ADDENDUM NUMBER: THREE (03)

ADDENDUM DATE: January 05, 2017

PROJECT: New Modular Police Building
Ahtahkakoop, Saskatchewan

M-3-9 REF. DRAWING M6.1 – DETAILS

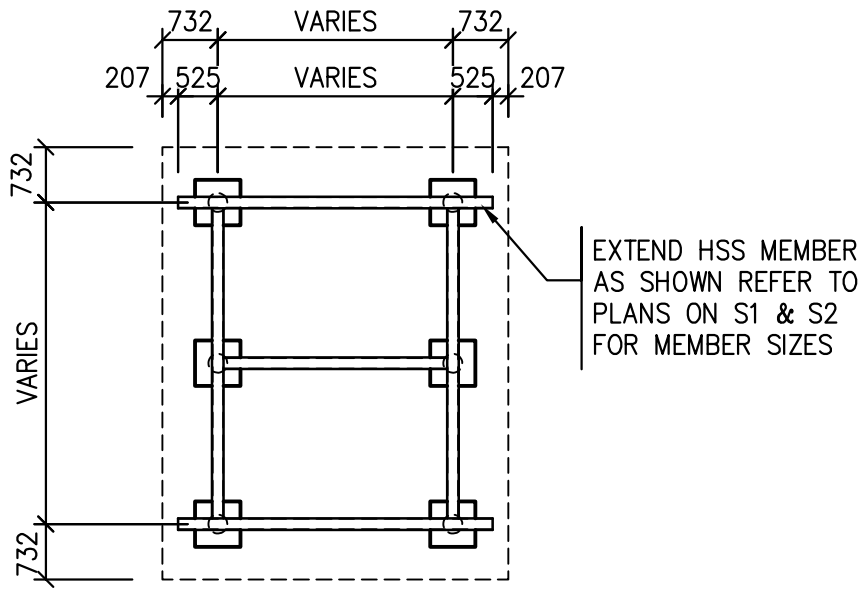
1. Under Security Duct Penetration Detail (For Ducts larger than 300x300) add the following note, “*Mechanical shall provide angle irons, where required, for all secure duct penetrations. Angle irons shall be prime painted where exposed and may be galvanized finish where concealed. Contractor shall confirm attack side of each and every penetration prior to mounting security bars.*”
2. Under Security Duct Penetration Detail (For Ducts larger than 300x300) add the following note, “*Wherever physically possible, the fire or fire/smoke damper shall be installed within the plane of the fire separation. If there are locations where out-of-wall fire dampers are required, request confirmation prior to commencing work.*”

HSS FRAME LAYOUT PLAN FOR UNITS 1-16

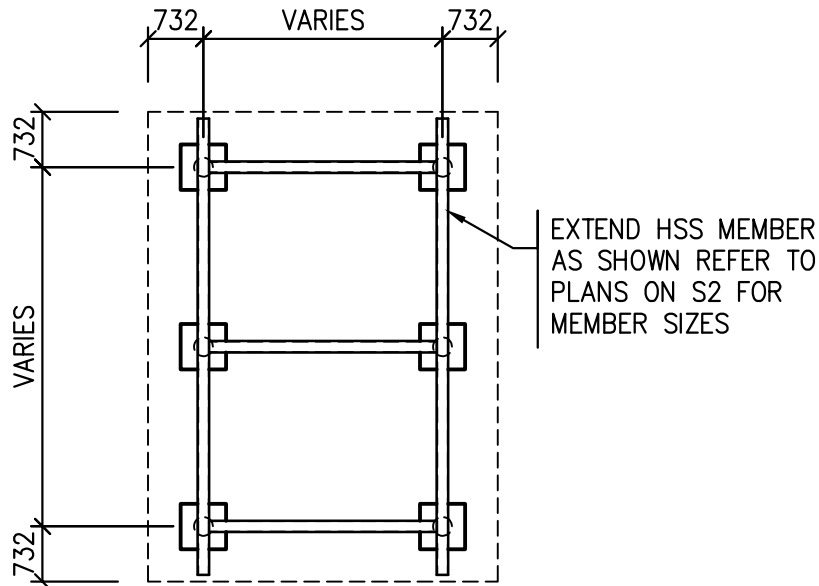
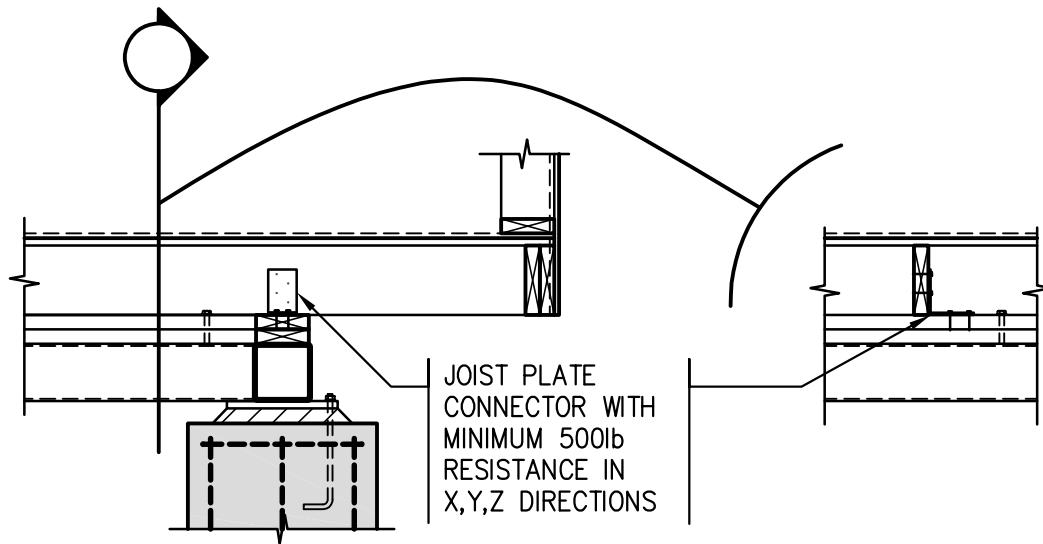
S-3-9 REF. DRAWINGS SK3 – HSS FRAME DETAIL

1. Replace sketch SK3 with sketch SK3-R1.

HSS TO FLOOR FRAMING CONNECTION DETAIL
FOR UNITS 1-16

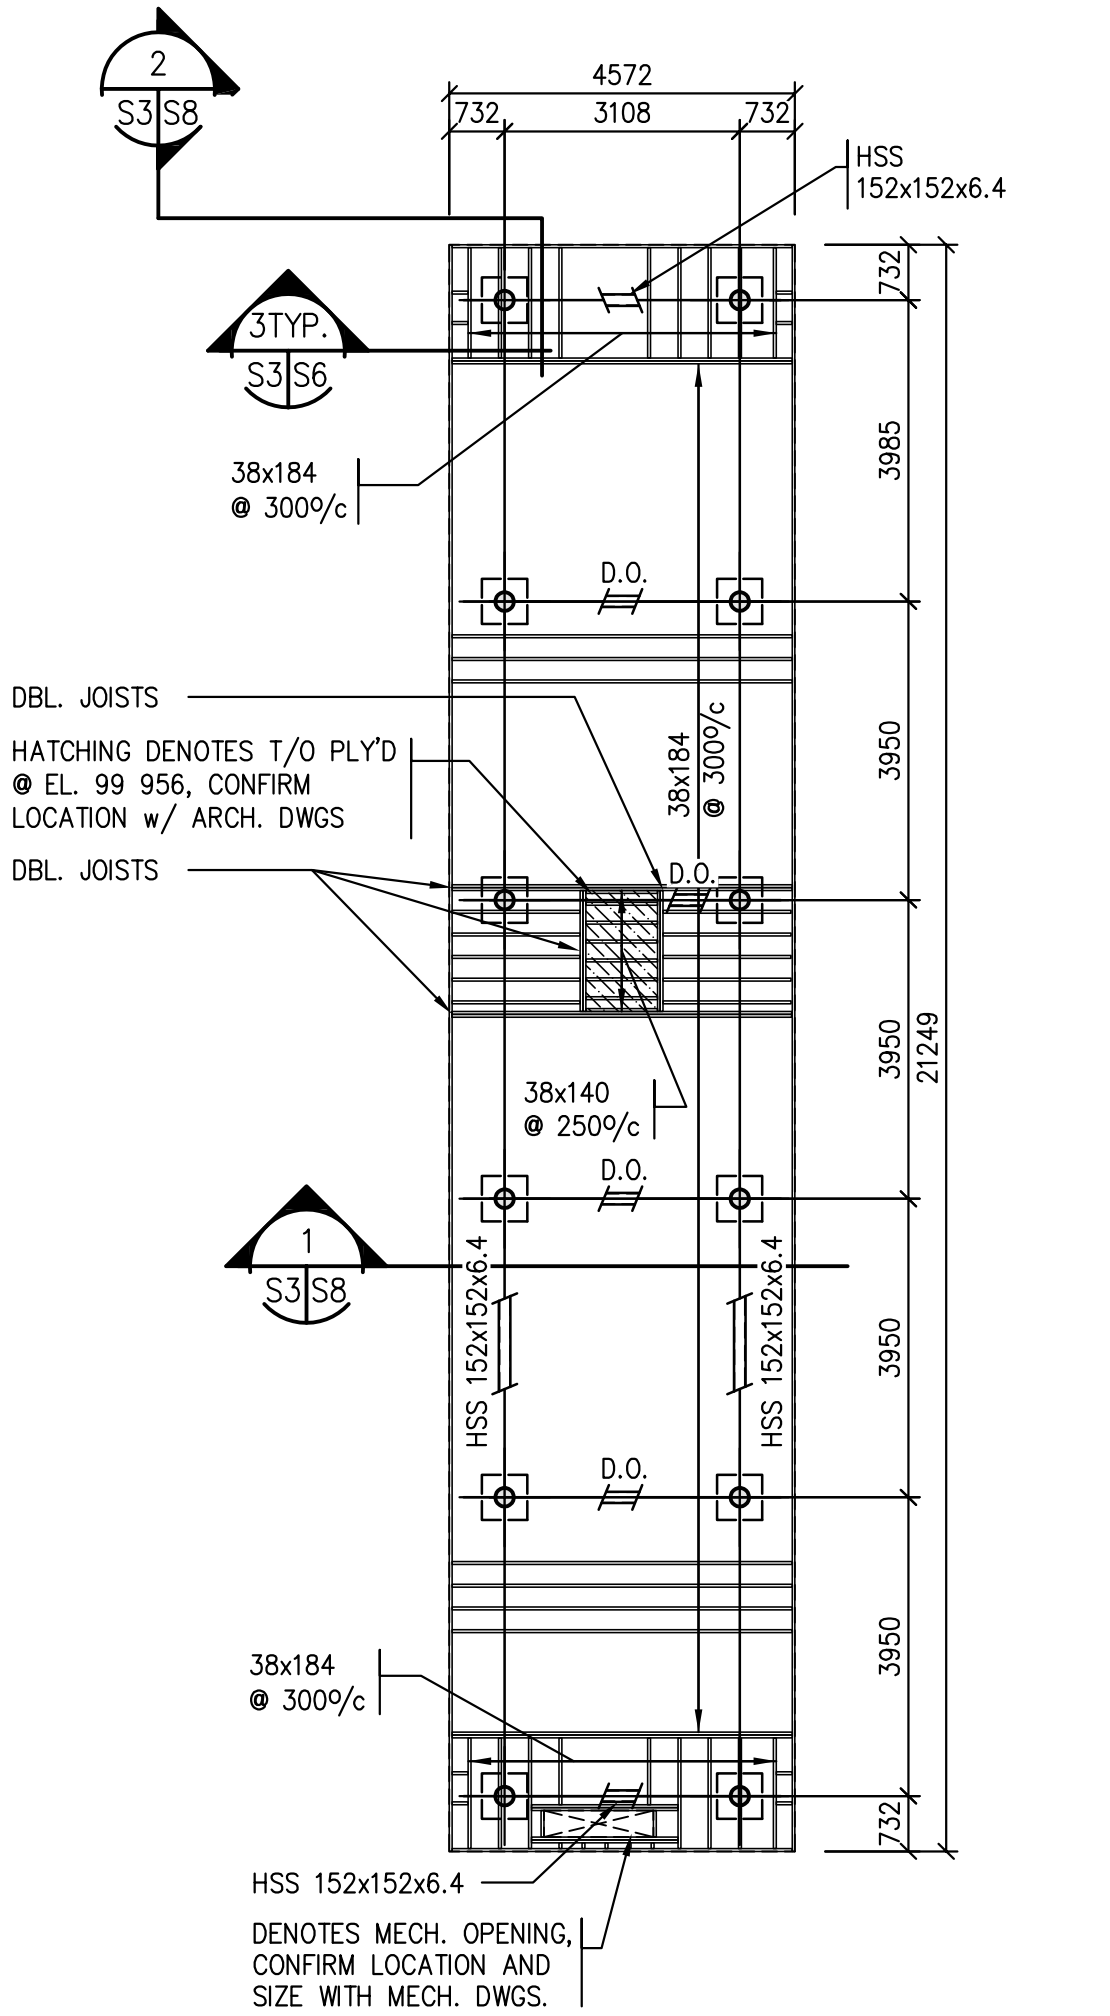
1. Refer to sketch SK5 HSS to Floor Framing Connection Detail for Units 1-16. This sketch is to replace the hurricane clip note for connecting the floor frames to the HSS frames.

5 FLOOR PLAN – UNIT 15
S1/S3 1:100

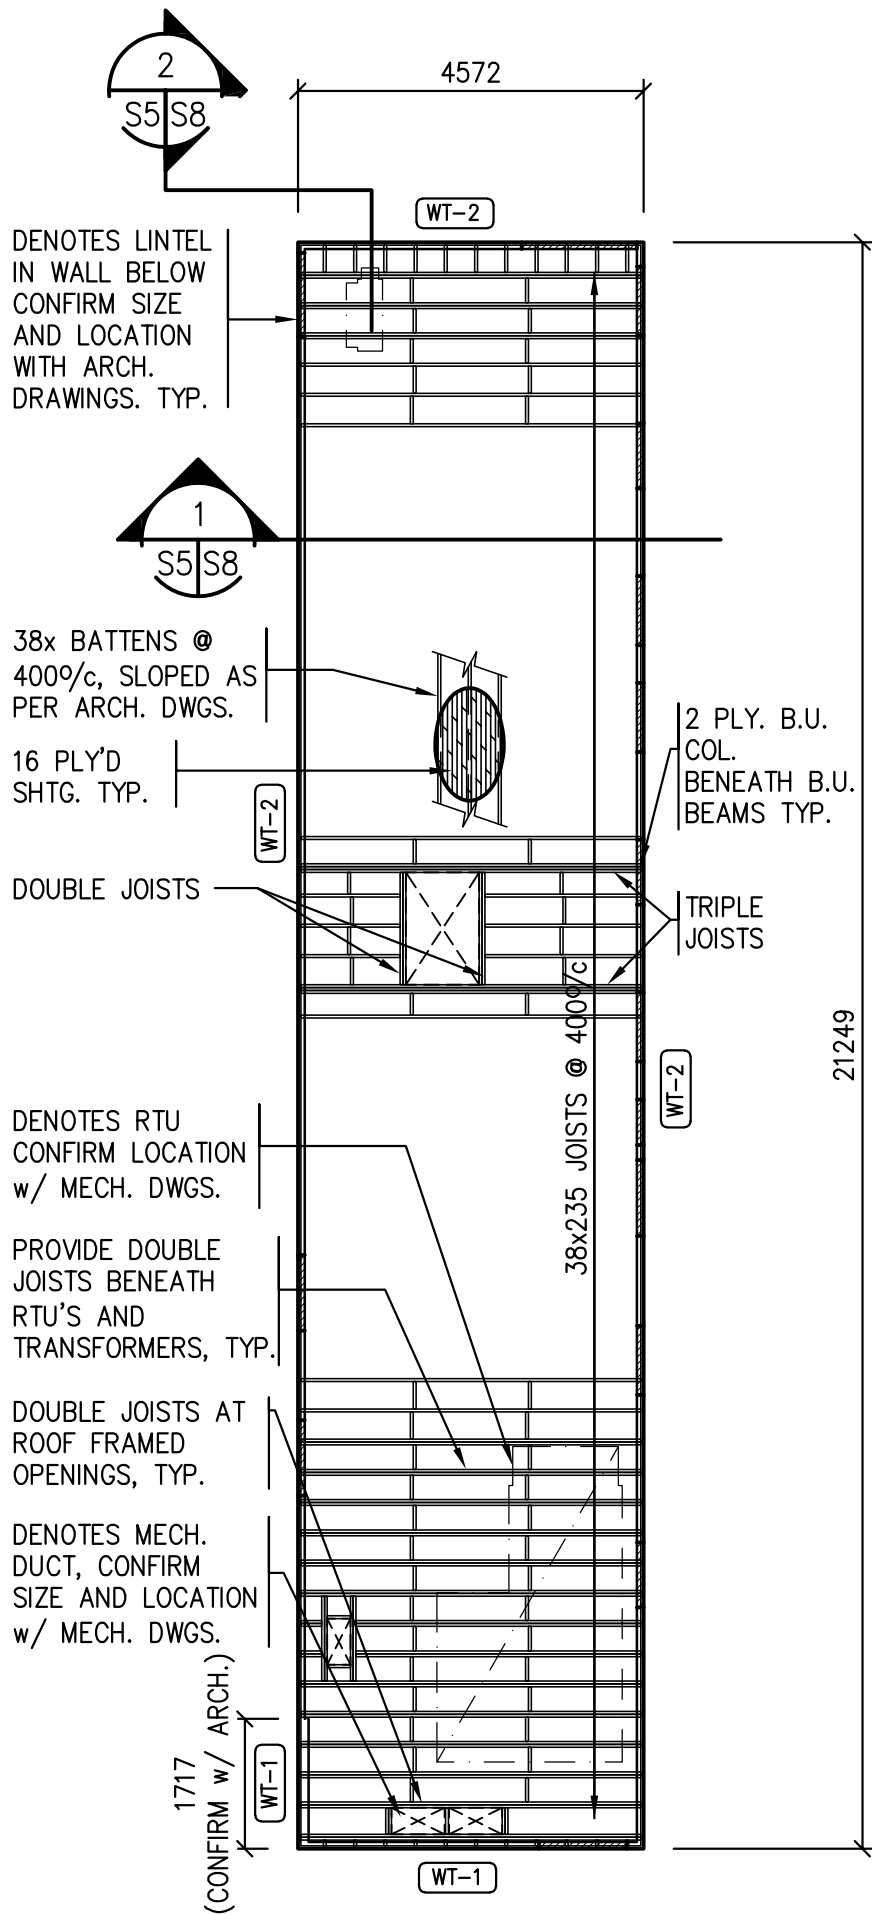
1. Floor plan 4/S3. Revise layout as per sketch SK10
2. Floor Plan 5/S3. Replace Floor Plan with sketch SK6. The floor framing has been revised to provide drop in floor framing for shower.
3. Refer to “*Notes Apply to Units 13 & 14/S3*”. Revise title from “*Units 13 & 14*” to “*Units 17 & 18*”.
4. Refer to “*Notes Apply to Units 1-12, 15-18/S2 & S3*”. Revise title from “*Units 1-12, 15-18/S2 & S3*” to “*Units 1-16/S2 & S3*”.

6 ROOF PLAN – UNIT 15
S1 | S5 1:100

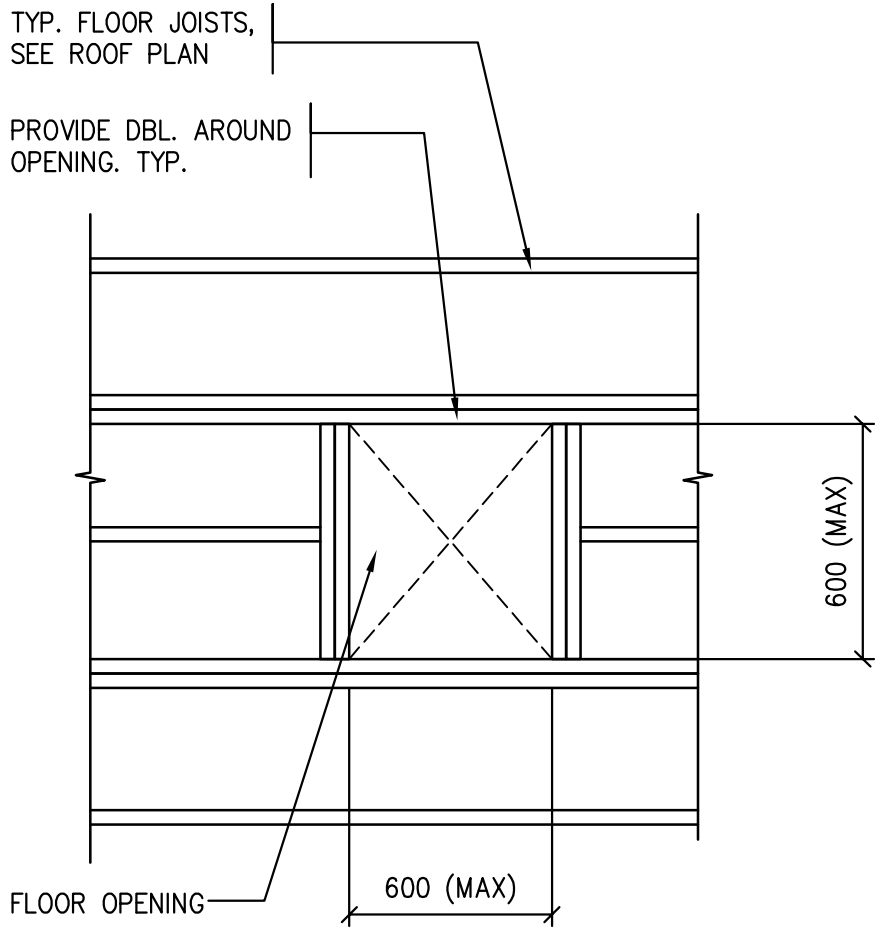
1. Roof Plan 6/S5. Replace Roof Plan with sketch SK7. The roof plan layout has been revised to accommodate mechanical duct work.

TYP. FLOOR OPENING DETAIL

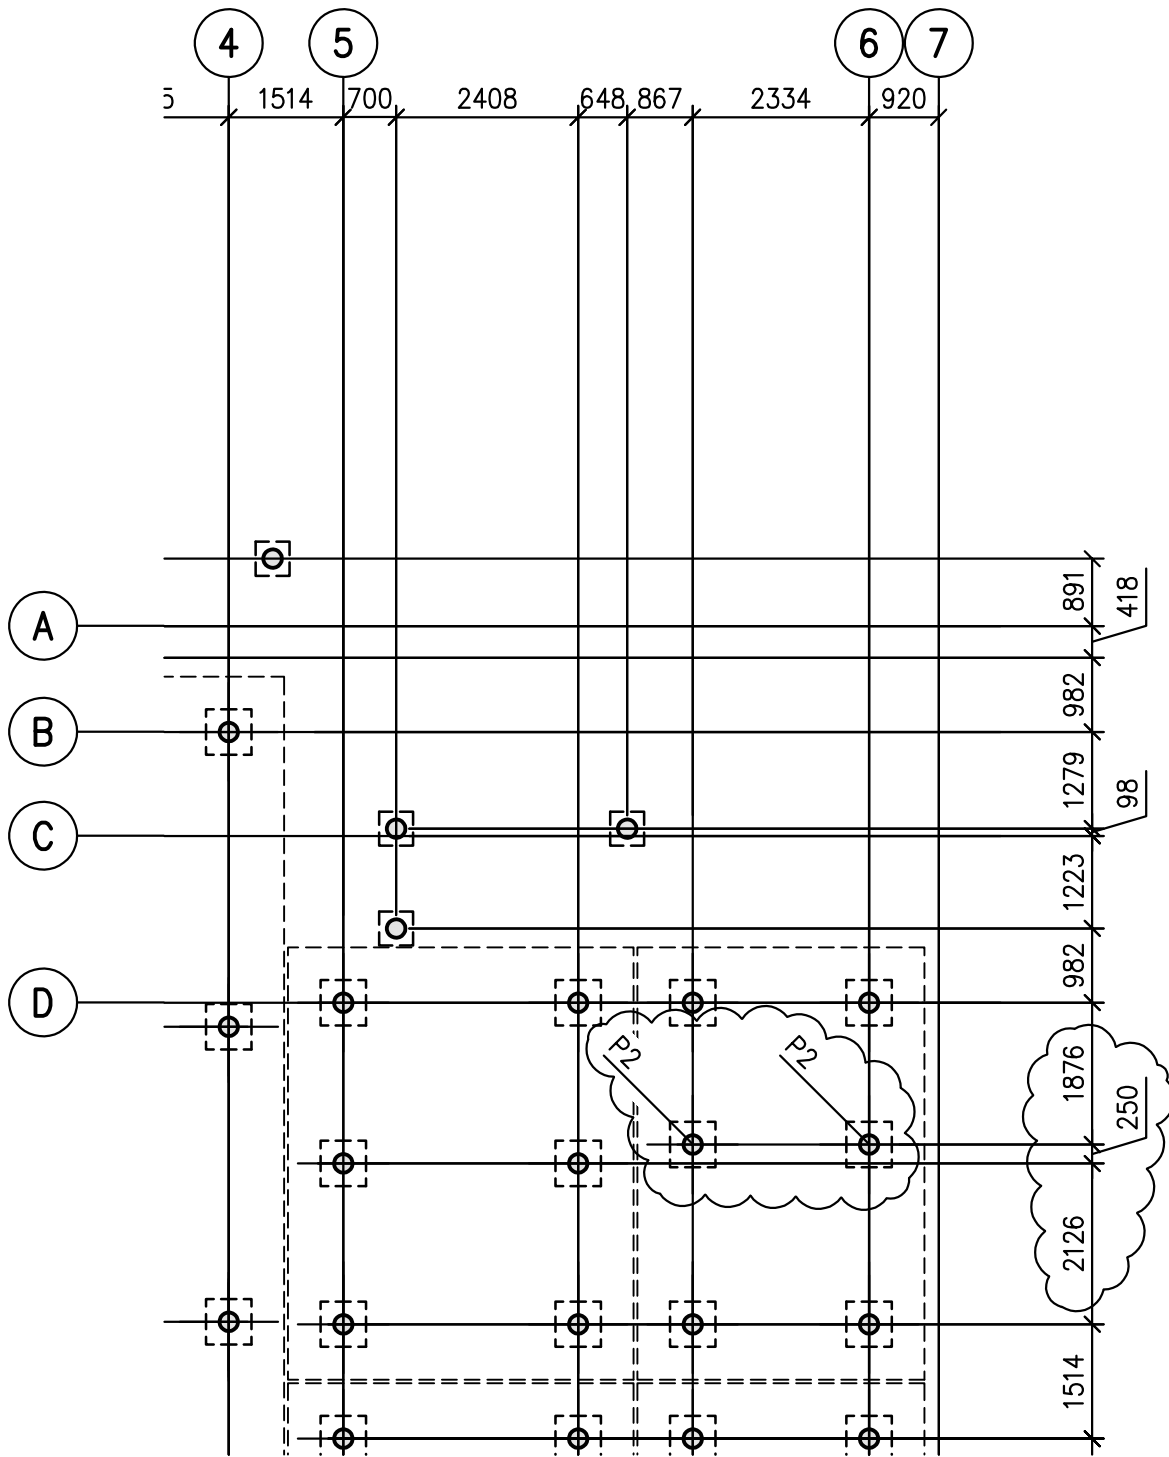
1. Add sketch SK8, Typ. Floor Opening Detail.

1 PARTIAL PILE PLAN
 SK9/SK9 1:100

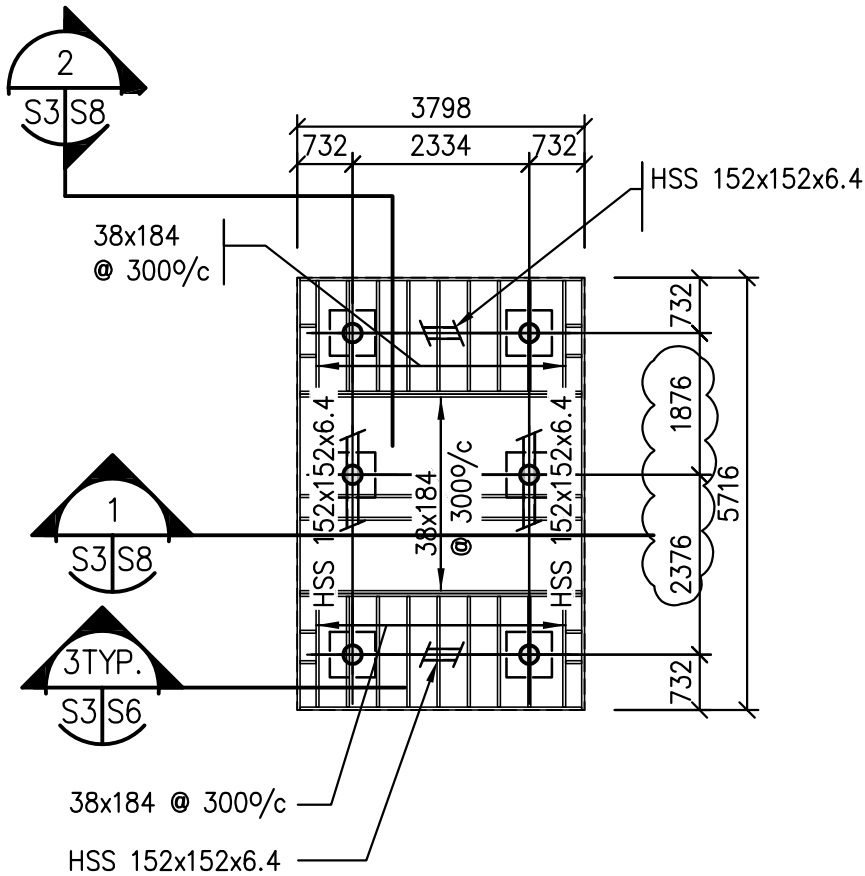
1. See 1/S1. Revise pile layout as per sketch SK9.
